Department of Energy

MAPS OF TRENCHES

Yucca Mountain trench 2.  
 Trench trends N. 60° W.  
 Southwest wall mapped.

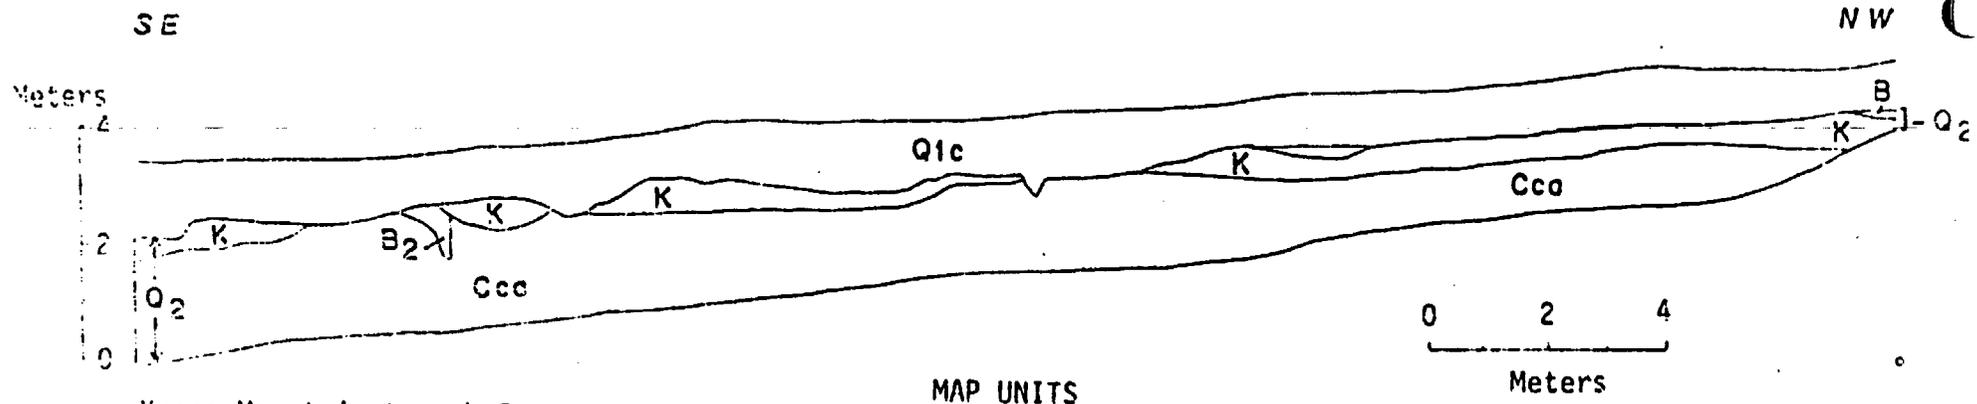
I regret the delay in communicating this information; however, my note to follow up got buried in my files on the DOE/NRC Geology Workshop. After the above mentioned workshop, we provided the NRC staff and their consultants a tour of Yucca Mountain. One area of investigation that was of particular interest was the trenching across the faults. Attached is a "map" that was given to the NRC staff showing what was known about the trenches. At the debriefing sessions, they indicated that these maps were inadequate from their viewpoint. They were viewed as cartoons rather than maps.

I am not sure if what was handed out was the real scientific map. However, this does stand as a question that we must resolve with the NRC. I would like to discuss it briefly as well as the course of action to be taken to correct any shortcomings, if they exist.

SETH - I TALKED TO BILL WHEN I GAVE HIM THIS NOTE. HE SAID THE USGS CONSIDERS THE MAPS AS INTERPRETED DATA AND THEREFORE DO NOT AUTHORIZE THEIR RELEASE UNTIL REVIEWED. YOU INDEED DID GET A CARTOON. THERE ARE MORE DETAILED MAPS
